# Summary of Changes

Project  
87 Frognaal

Drawing Title  
West Elevation

Project Number	Drawing Number	Revision
1317	AP 08

Proposed West Elevation  
1:50

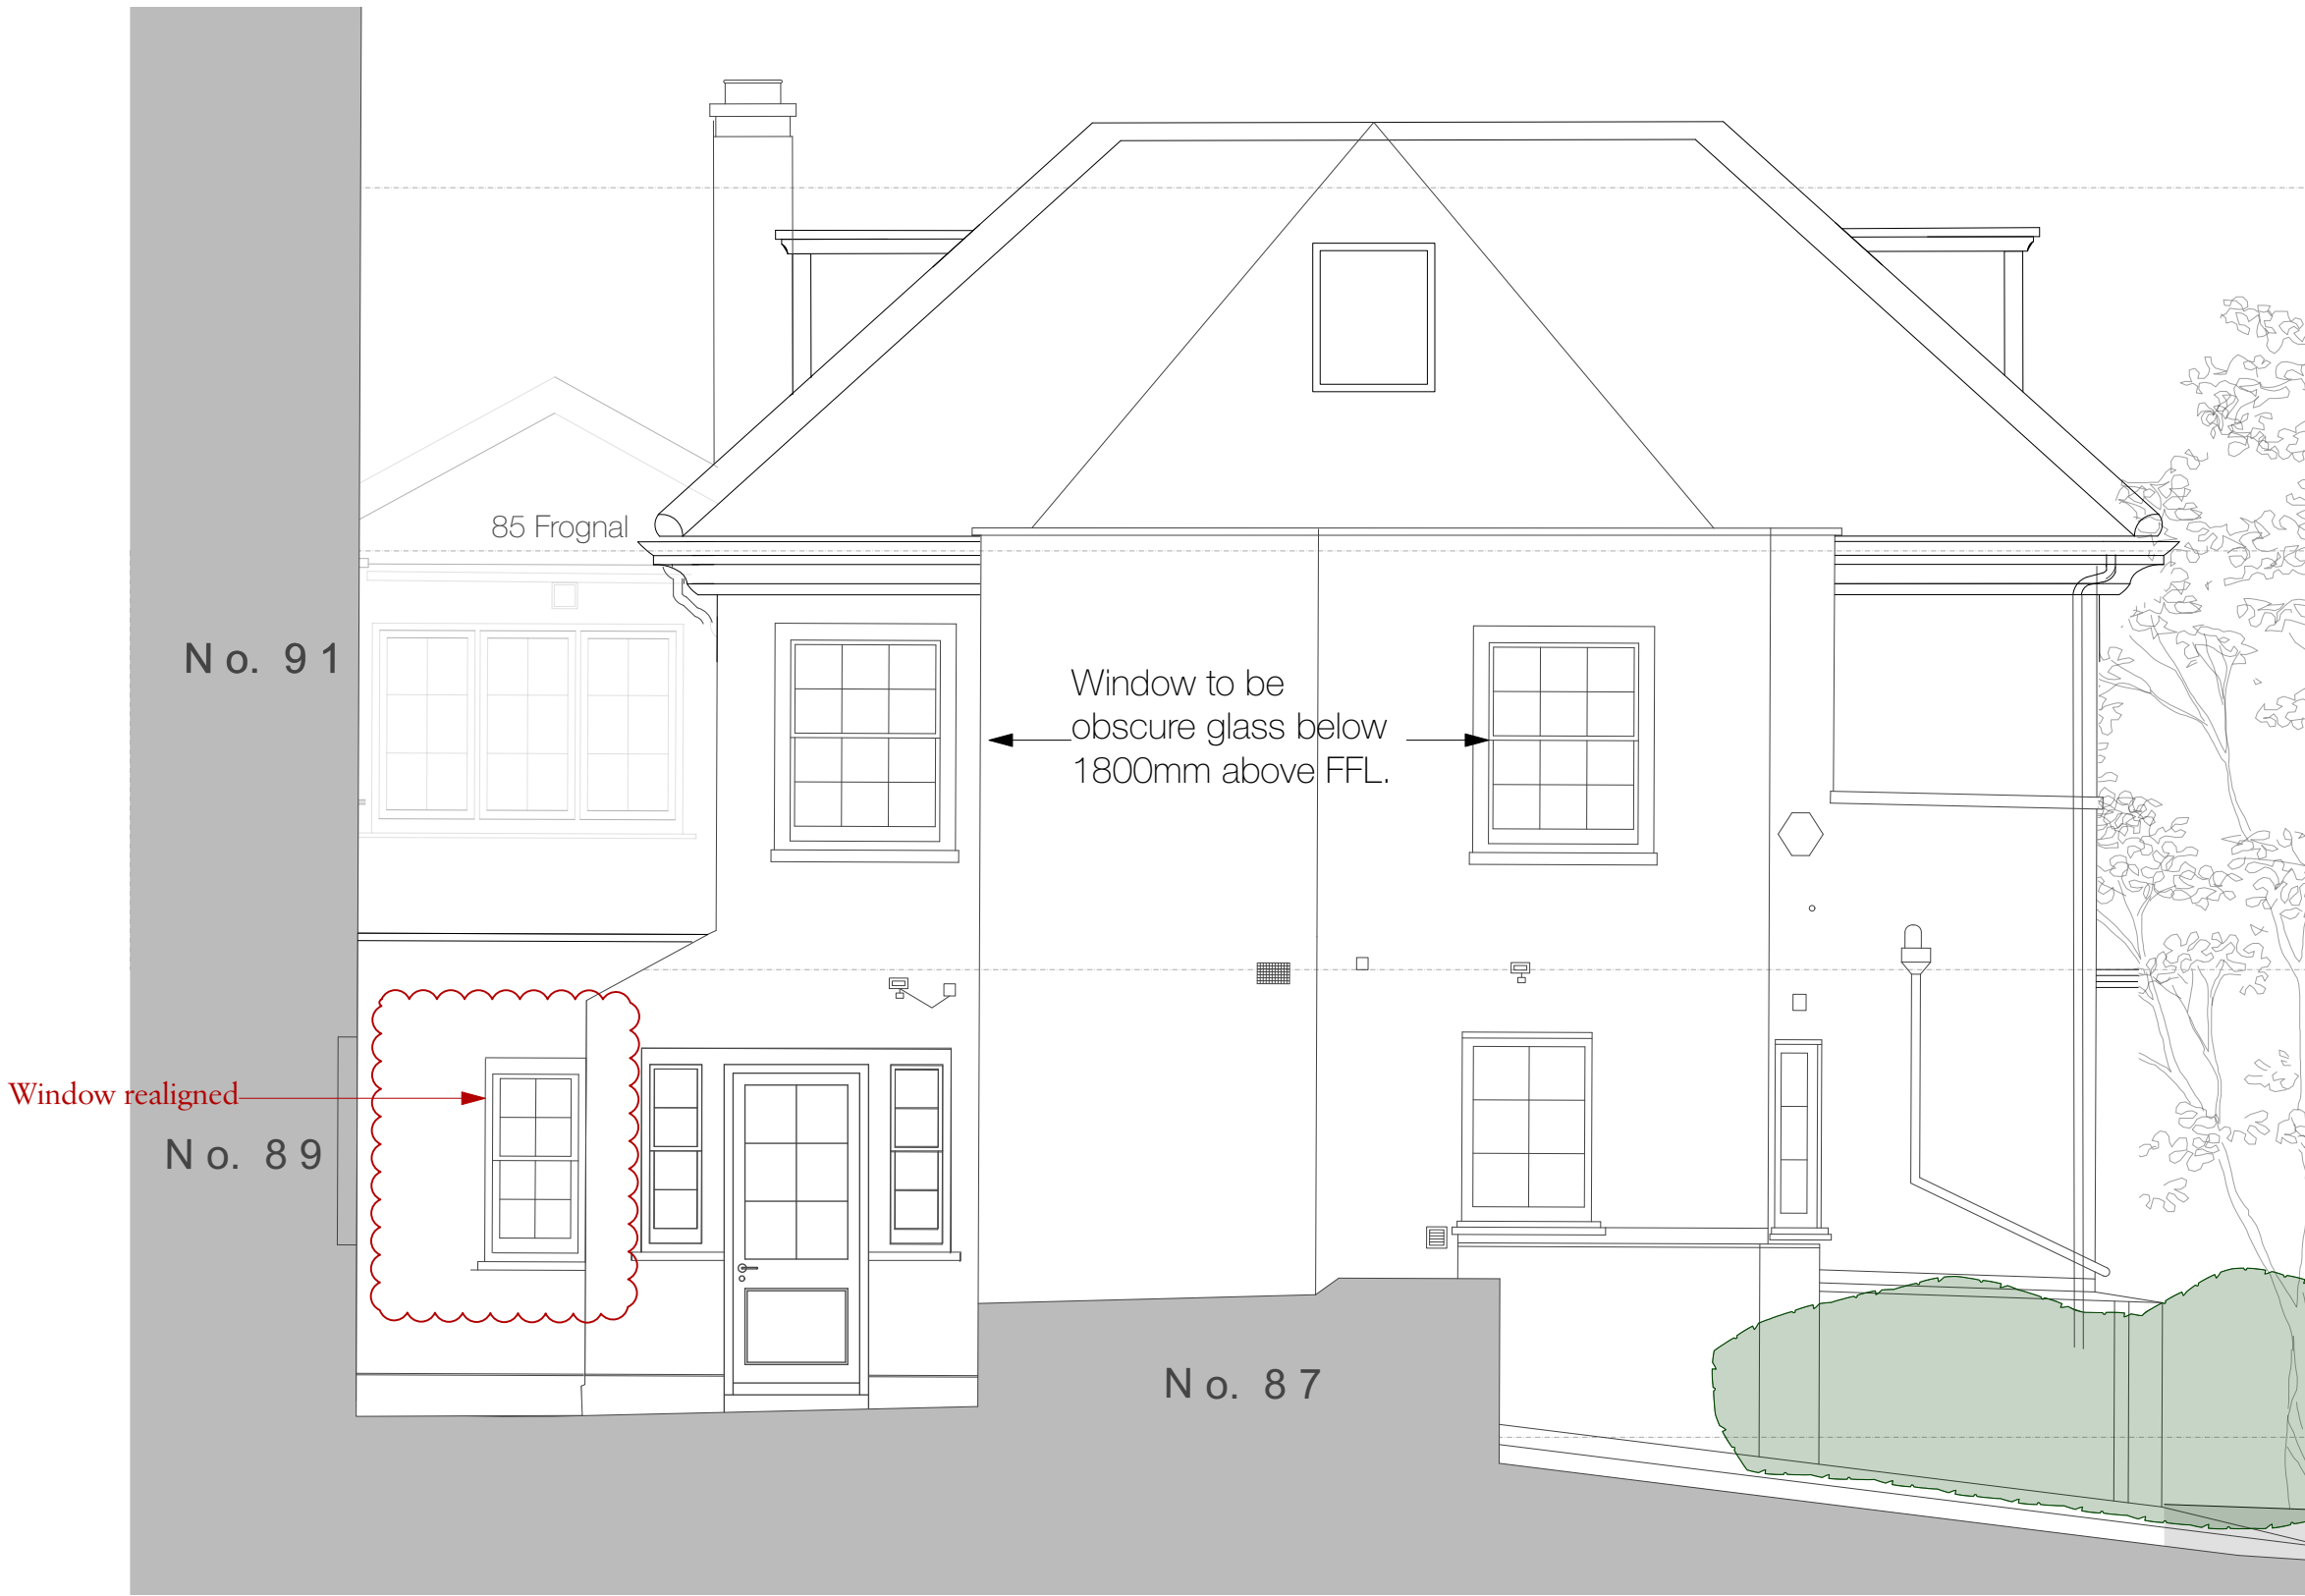
Dining Room window realigned to suit new interior layout
